State of New Mexico
Energy Minerals and Natural Resources
Department
Oil Conservation Division
1220 South St. Francis Dr.
Santa Fe, NM 87505

Recycling Facility and/or Recycling Containment

1.
Operator: Enduring Resources IV, LLC (For multiple operators attach page with information) OGRID #: 372286
Address: 200 Energy Court, Farmington, New Mexico 87401
Facility or well name (include API# if associated with a well): NEU 2207-16B Water Recycle Facility / Containment
OCD Permit Number: #3RF-28 (For new facilities the permit number will be assigned by the district office)
U/L or Qtr/Qtr NW/4 NE/4 Section 16 Township 22N Range 7W County: Sandoval
Surface Owner: Federal State Private Tribal Trust or Indian Allotment

Enduring Resources IV, LLC
NEU Unit 2207-16B Recycling Facility / Containment
#3RF-28
Modification

PRODUCED WATER PIT 1
LEAK DETECTION C109
 N.T.S.

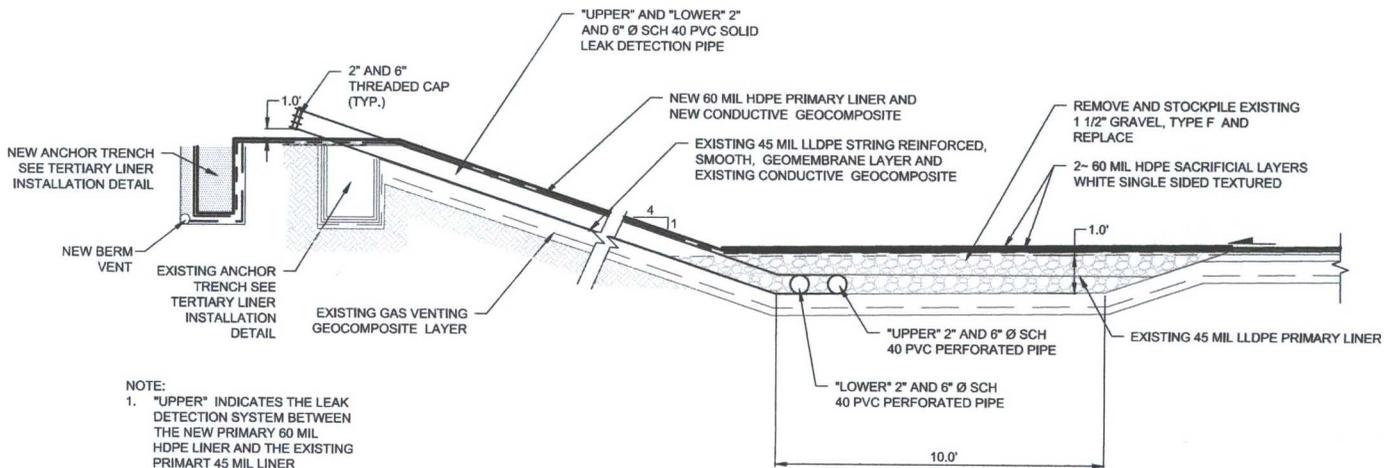
Modification to Leak Detection: Addition of a second leak detection system.

For reference there will be an upper and lower leak detection system in this containment.

Upper leak detection system: (New)

The leak detection system between the Primary (new) and the secondary (existing) lower geomembrane liner consists of a 200-mil geo net to facilitate drainage. The leak detection system consists of a properly designed drainage, collection and removal system placed above the secondary (existing) geomembrane liner in depressions and sloped to facilitate the earliest possible leak detection. A 3-foot-wide by 3-foot-long by 2-foot-deep depression will be constructed to allow for collection of any leaking liquid. A 2-inch and 6-inch PVC pipe will be installed in between the primary (new) and secondary (existing) liners from the top of the containment depression to allow for detection and removal of

- NOTE:
1. "UPPER" INDICATES THE LEAK DETECTION SYSTEM BETWEEN THE NEW PRIMARY 60 MIL HDPE LINER AND THE EXISTING PRIMART 45 MIL LINER
 2. "LOWER" INDICATES THE LEAK DETECTION SYSTEM BETWEEN THE EXISTING PRIMARY 45 MIL LLDPE AND THE EXISTING SECONDARY 45 MIL LLDPE.

1. SLIT EXISTING PRIMARY LINER TO ACCESS GRAVEL FILLED SUMP AND INSTALL NEW LEAK DETECTION PIPING.
2. REMOVE 1 1/2" GRAVEL TYPE F AND STOCKPILE.
3. INSTALL "LOWER" LEAK DETECTION PIPING INTO SUMP.
4. PLACE 6" OF 1 1/2" GRAVEL TYPE F TO TOP OF "LOWER" LEAK DETECTION PIPING.
5. WELD EXISTING PIT LINER SLIT. PLACE EXISTING PRIMARY LINER OVER "LOWER" LEAK DETECTION PIPING AND GRAVEL.
6. INSTALL "UPPER" LEAK DETECTION PIPING.
7. PLACE 6" OF 1 1/2" GRAVEL, TYPE F TO TOP OF "UPPER" LEAK DETECTION PIPING PLUS 4".
8. PLACE NEW CONDUCTIVE GEOCOMPOSITE OVER SUMP AND EXISTING POND PRIMARY LINER. PLACE NEW 60 MIL HDPE PRIMARY LINER OVER SUMP AND OVER ENTIRE EXISTING PRIMARY LAYER.
